Engineering revision handoff

Engineering file ID 26 | E1 builds on v11.4

Recovered hidden source hardware and corrected LED, PCB support, button-travel, microphone and USB-access geometry while retaining Elian's exterior design.

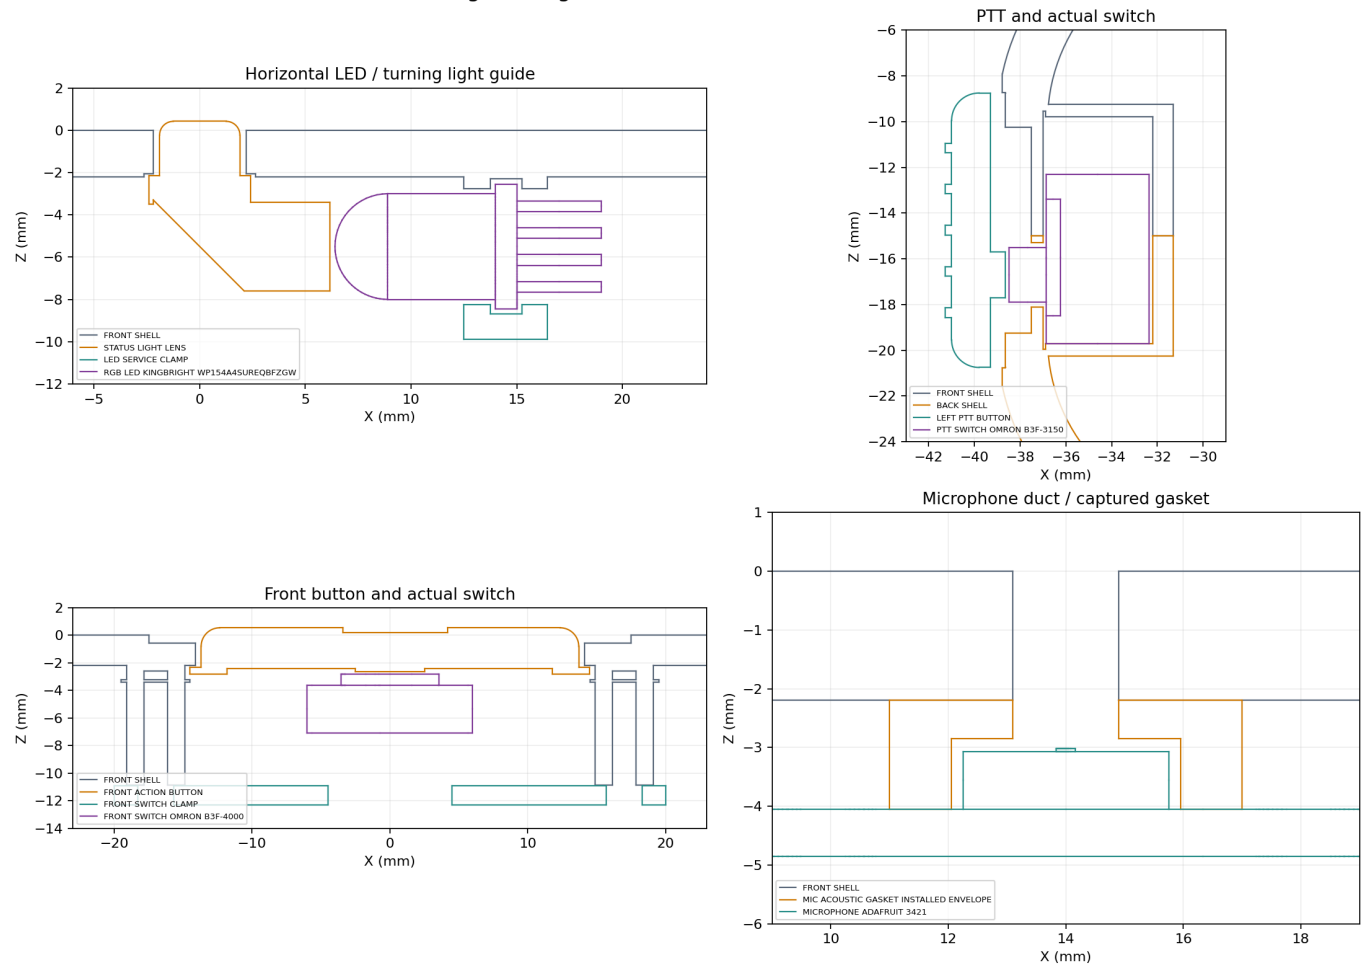
- Recovered the installed source electronics from native Fusion; the earlier neutral assembly omitted them.
- Relocated the RGB LED sideways, added a removable clamp and a turning light guide, and relieved the old collector interference.
- Revised PCB bearing locations and button travel pockets; trimmed the PTT end beside USB.
- Aligned the microphone duct to the actual port and added a captured gasket envelope.
- Moved conservative USB access clearance to the measured receptacle-mouth axis.

- Ten custom STEP parts are valid single solids. Sampled side travel through 0.65 mm and front travel through 0.70 mm clear fixed-body checks.
- The raw static report retains two LED screw/pilot thread-region intersections; these do not establish a qualified screw process.
- The conservative USB gauge still overlaps the PCB/mating region by about 59.001 mm³. Exact plug mating is unresolved.

1. Use the recovered installed hardware positions to inspect the revised case assembly.
2. Fit the side-facing LED into the split clamp with two M2 x 6 flat-head screw envelopes; avoid a tight bend next to the LED body.
3. Fit the turning light guide and verify light output on a physical sample.
4. Seat the microphone over its aligned duct using a qualified gasket; the CAD gasket is a compressed envelope.
5. Resolve switch rear reaction support and verify the selected USB cable before any functional build.
